Re: Tract N-1-B Watershed Subdivison - Sketch Plat Submittal

REQUEST: Sketch Plat review for Tract N-1-B Watershed
IDO -2022

Development Facilitation Team (DFT) – Review Comments

DRB Project Number: 2024-010571
Arroyo Vista – Watershed Subdivision

PLAT OF
TRACTS N-1-A & N-1-B
WATERSHED SUBDIVISION
(A REPLAT OF TRACT N-1,
WATERSHED SUBDIVISION)
PROJECTED SECTIONS 17 AND 18,
TOWNSHIP 10 NORTH, RANGE 2 EAST,
N.M.P.M.
ALBUQUERQUE,
BERNALILLO COUNTY, NEW MEXICO
AUGUST, 2023

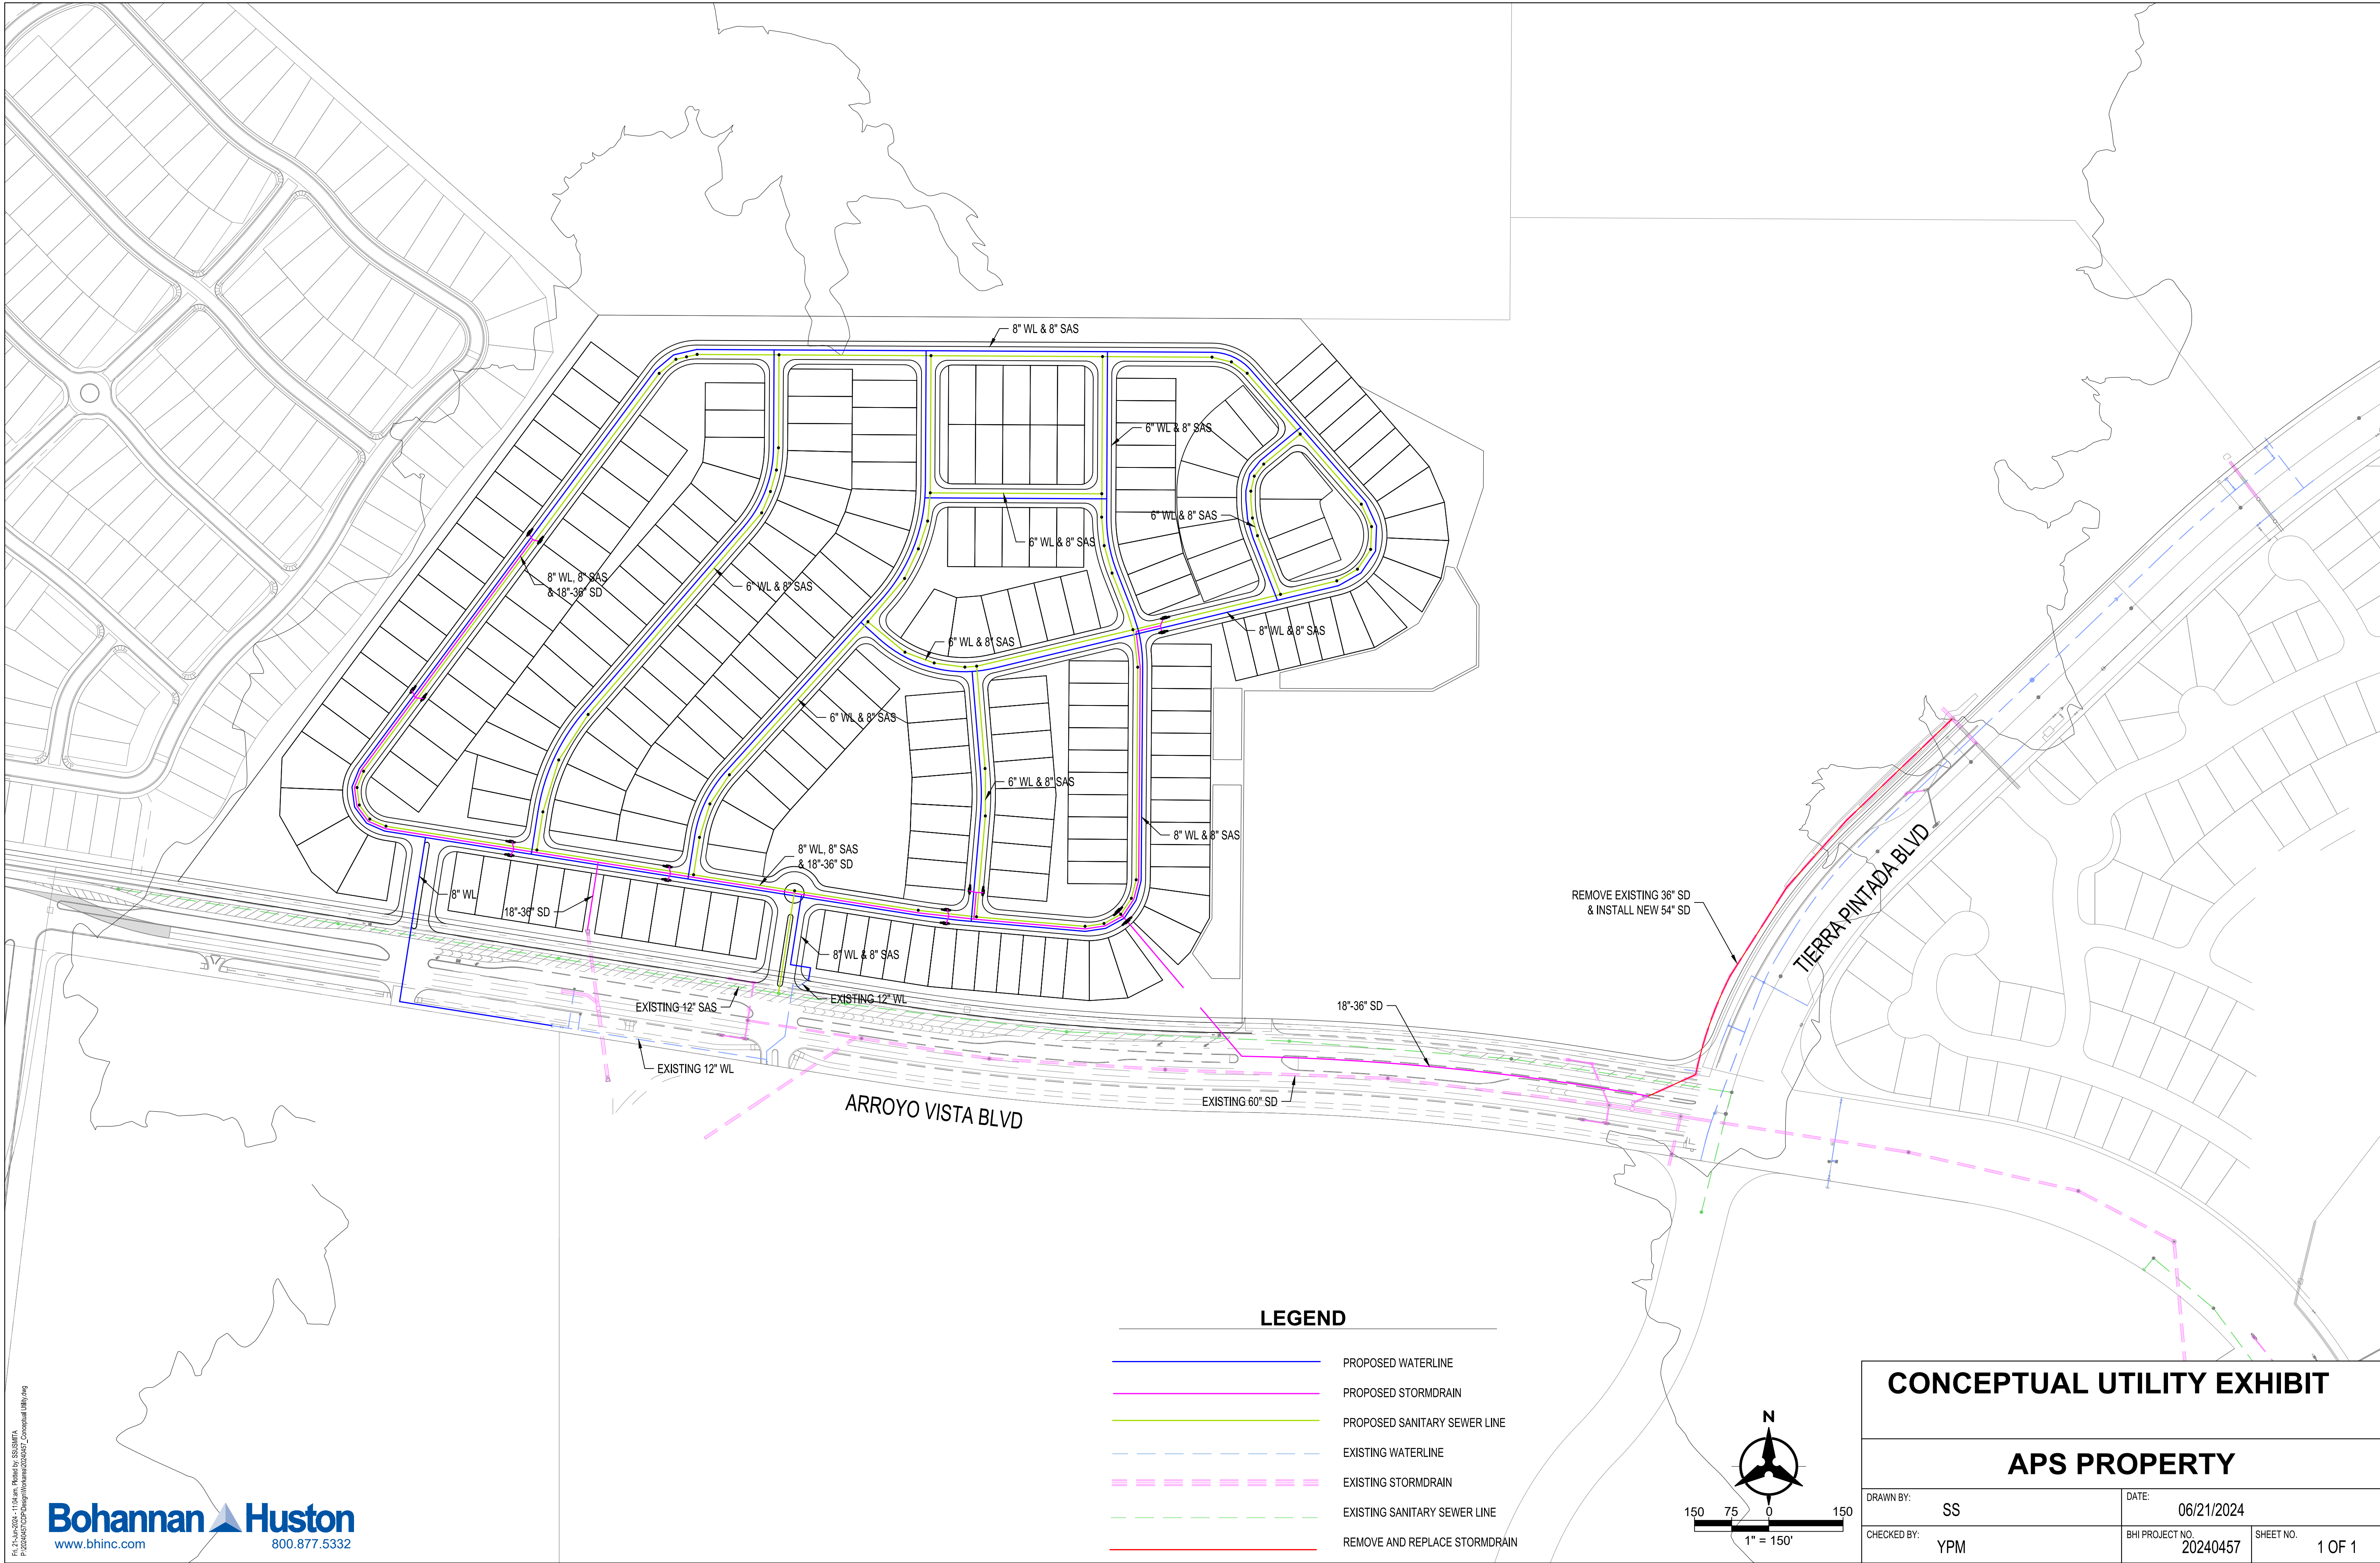
1. Arroyo Vista is a Principal Arterial and requires a 6' sidewalks with a 5' to 6' landscape buffer. There is an existing multiuse trail along here which meets sidewalk requirements.
2. All internal roads would be local roads and require 5' sidewalk with a 4' to 6' landscape buffer.
3. Prior to site plan an approved TCL is required. Also, please submit a Traffic Scoping Form to Curtis Cherne (ccherne@cabq.gov) to determine if a TIS is required.

- Hydrology will need to approve a Conceptual Grading & Drainage Plan prior to platting.
- The infrastructure list will be needed for Preliminary Plat.
- Hydrology will also need AMAFCA's approval prior to plat approval.

It is noted that a single-loaded street has been placed on the edge of the subdivision adjacent to Petroglyph National Monument which meets of the requirements of 5-2(J).

It would appear that you have been able to keep some block lengths under 600 feet, but some are not.

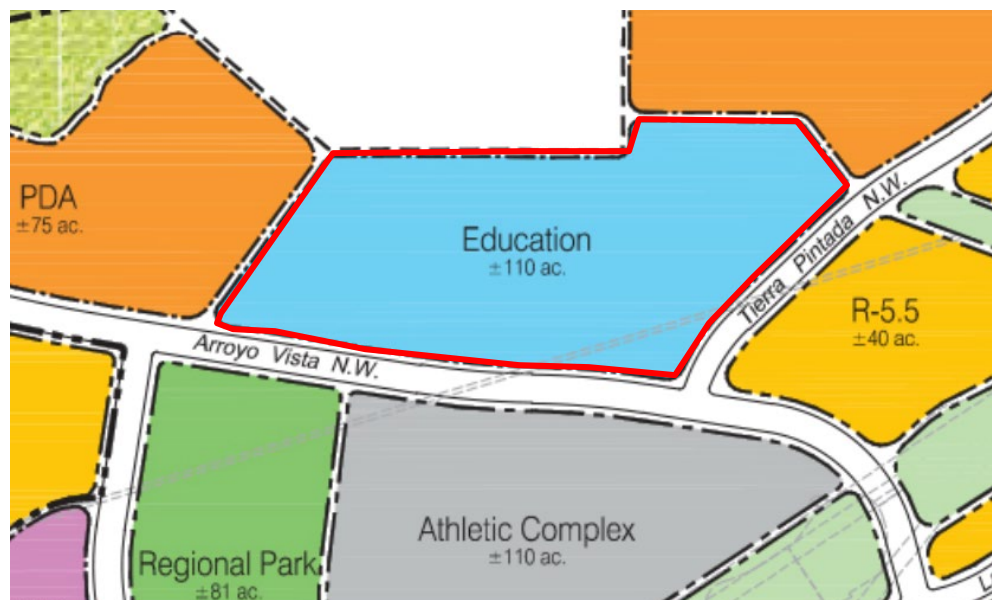
- A previous sketch plat was reviewed April 17, 2024. That Sketch Plat review request was for a Bulk Land Plat, subdividing an existing tract, Tract N-1 of the Watershed subdivision, into Tract N-1-B at 60.0839-acres in size and Tract N-1-A at 49.9-acres in size. **Tract N-1-A and Tract N-1-B still need to be created. Tract N-1-B could then be further subdivided.**

- The subject property is zoned PC (Planned Community), is located at 9601 Tierra Pintada Blvd., and features the Tres Volcanes Community Collaborative School on the eastern portion of the subject property (future Tract N-1-A as depicted on the Sketch Plat). The western portion of the property is vacant (future Tract N-1-B). The parcel is owned by Albuquerque Public Schools (APS).

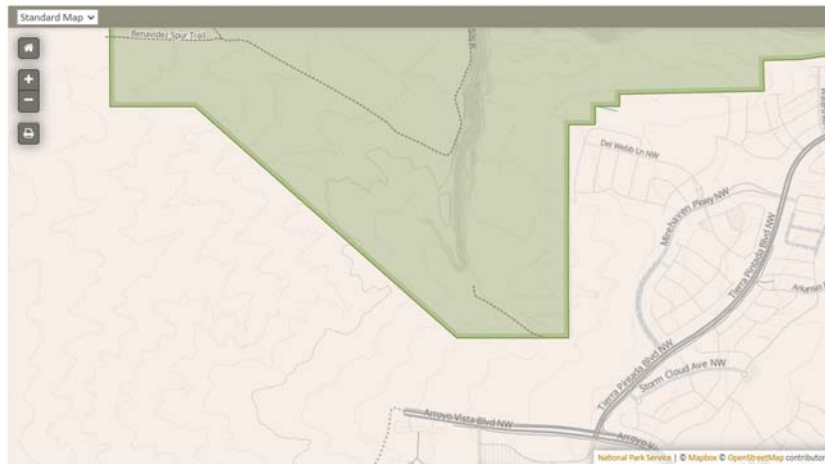
The subject site is adjacent to MPOS (Petroglyph National Monument) along the northern property line.

6-5(G)(1)(e) Where adjacent to Major Public Open Space, a Site Plan – Administrative may only be approved for a project site of no more than 5 acres. Development on a project site over 5 acres and adjacent to Major Public Open Space requires a Site Plan – EPC pursuant to Subsection 14-16-6-6(J).
